Agenda Item 1
January 23, 2017

SUBJECT: Consideration of tentative approval of the request of Hadley's Towing, JSP 16-33, with Zoning Map Amendment 18.715, to rezone property in Section 17, located on the south side of Grand River Avenue between Wixom Road and Beck Road from I-1, (Light Industrial) to I-2 (General Industrial) subject to a Planned Rezoning Overlay (PRO) Agreement, and corresponding PRO Concept Plan. The property totals 17.78 acres and the applicant is proposing to rezone approximately 5.6 acres of the northerly portion of the property to accommodate a vehicle towing business and outdoor storage yard.

PLANNING REVIEW

Review Date: November 23, 2016
Review Type: PRO Concept Plan
Project Name: JSP 16-33 Hadley's Towing
Plan Date: August 11, 2016
Prepared by: Sri Komaragiri, Planner
E-mail: skomaragiri@cityofnovi.org; **Phone:** (248) 735-5607

CONCEPTUAL LAYOUT PLAN (SOUTH)

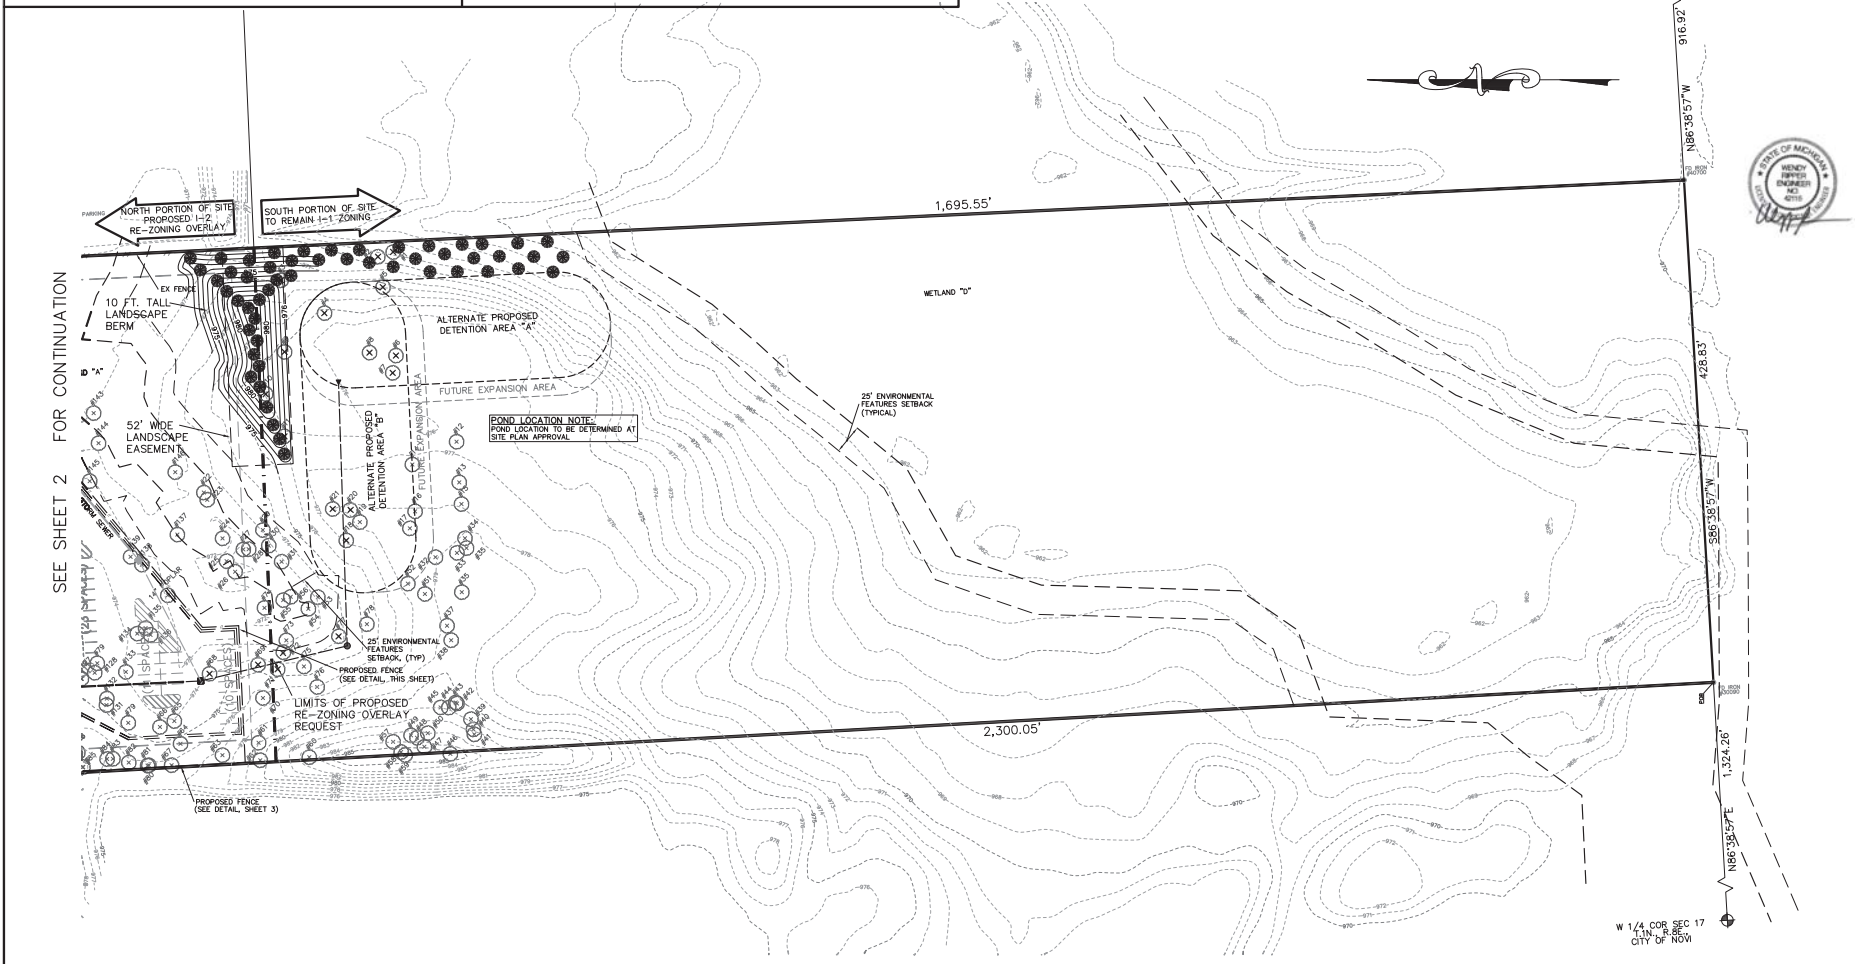
Soils are listed on Sheet 2.

2. Screening fence is proposed along the north property line to match the existing fencing along the eastern property line. The plan view note on Sheet 2 indicates that this fence is non-transparent.

Figure 1. City of Novi Regulated Wetland & Woodland Map (approximate project area is highlighted in red). Regulated Woodland areas are shown in green and regulated Wetland areas are shown in blue).

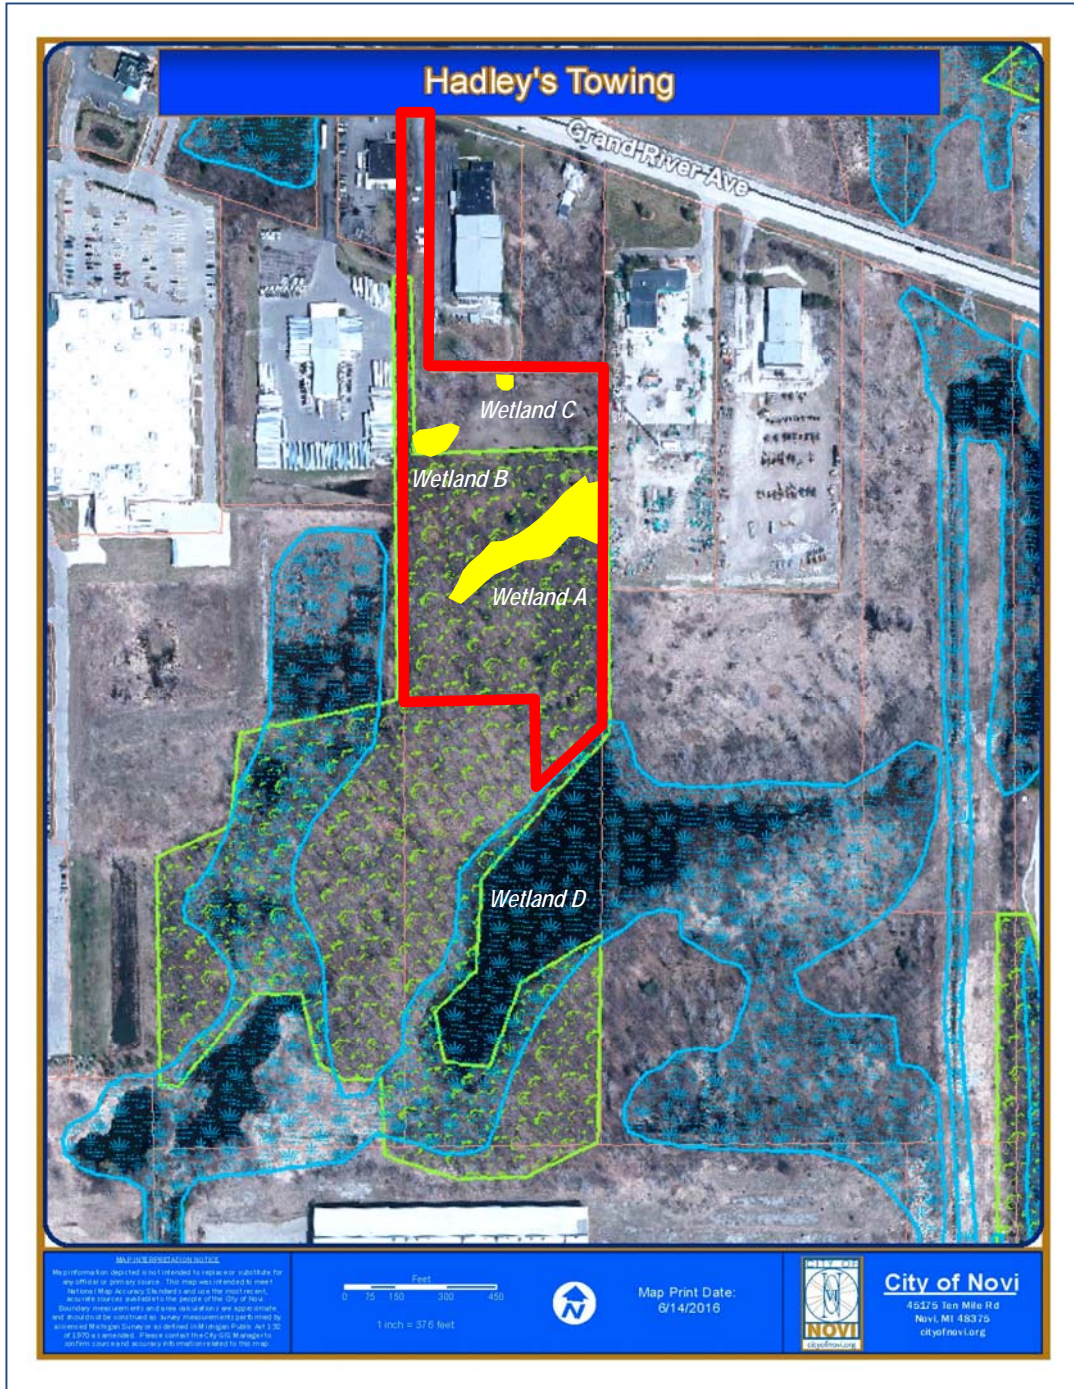
Based on our review of the Plan, Novi aerial photos, Novi GIS, the City of Novi Official Wetlands and Woodlands Maps (see Figure 1, attached) it appears as if this proposed project site contains City-regulated wetlands and woodlands. The City's wetland and woodland map shows that the overall property contains wetlands to the south. However, a review of aerial photos of the site, the proposed site plan, and previous site visits, the site contains four (4) total areas of wetland (Wetlands A, B, C, and D).

Figure 1. City of Novi Regulated Wetland & Woodland Map (approximate project area is highlighted in red). Regulated Woodland areas are shown in green and regulated Wetland areas are shown in blue).

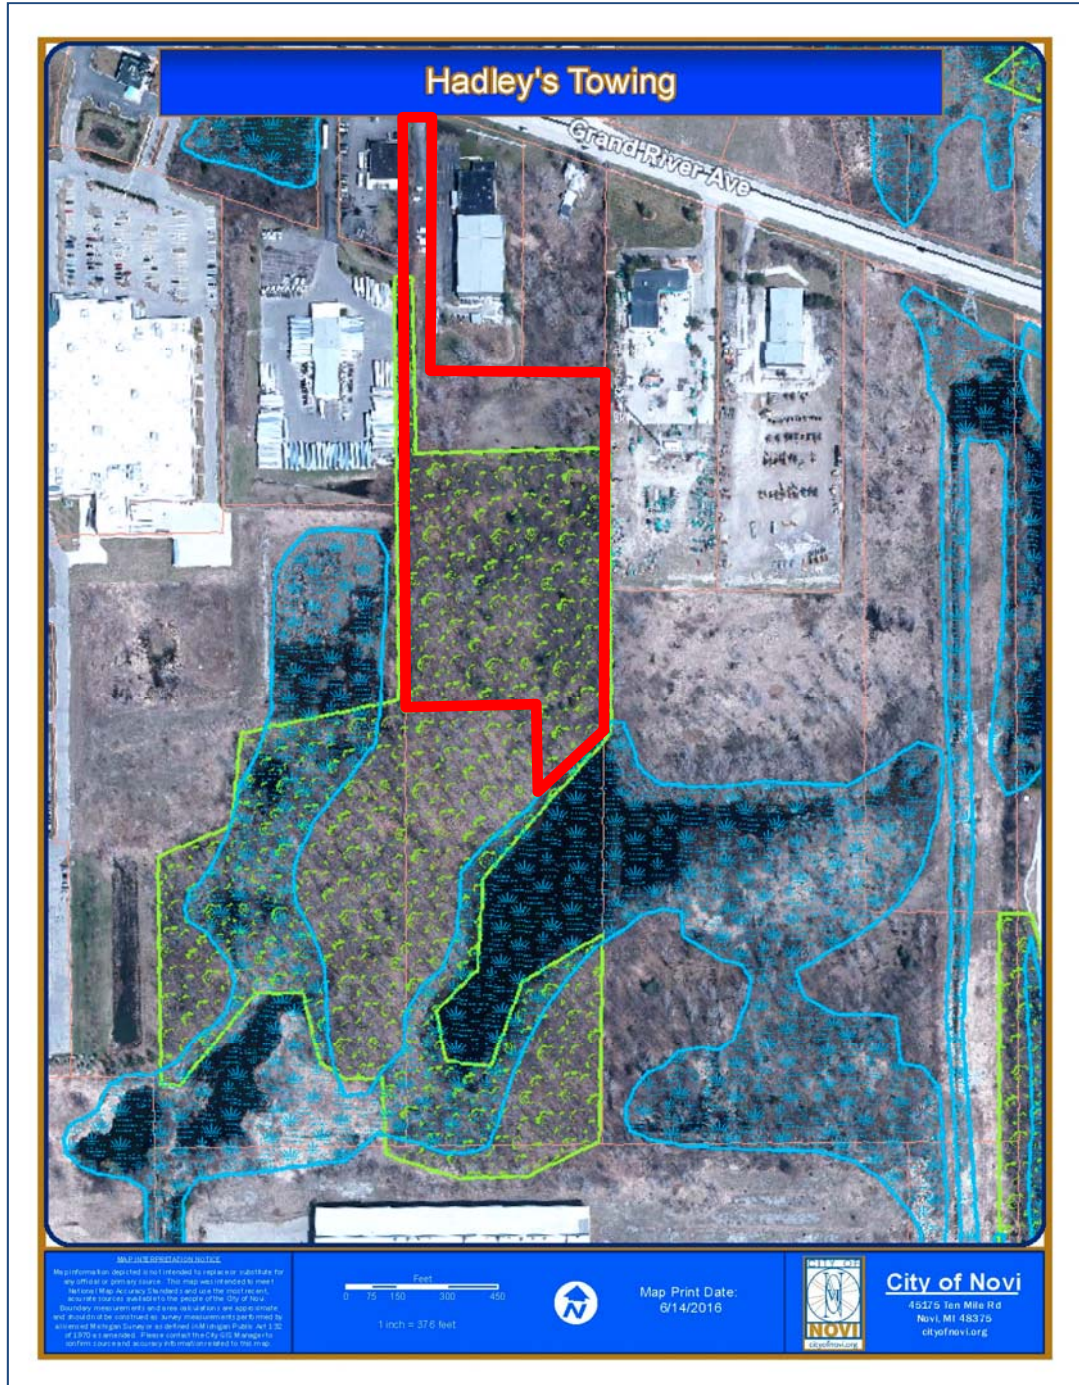
The site does contain areas noted as City of Novi Regulated Woodlands. The majority of the property contains Regulated Woodland (see Figure 1). The current plan includes a partial tree list and a partial list of the proposed tree removals. The plan notes that *"tree locations on south portion of site not available at time of concept plan submittal"*. As such, the total impact to existing trees associated with the proposed detention basin and associated stormwater outfall pipe are not calculated on the Plan. The previously submitted concept plan stated that *"tree survey to be performed on south portion of property at the time of preliminary site plan submittal"*.
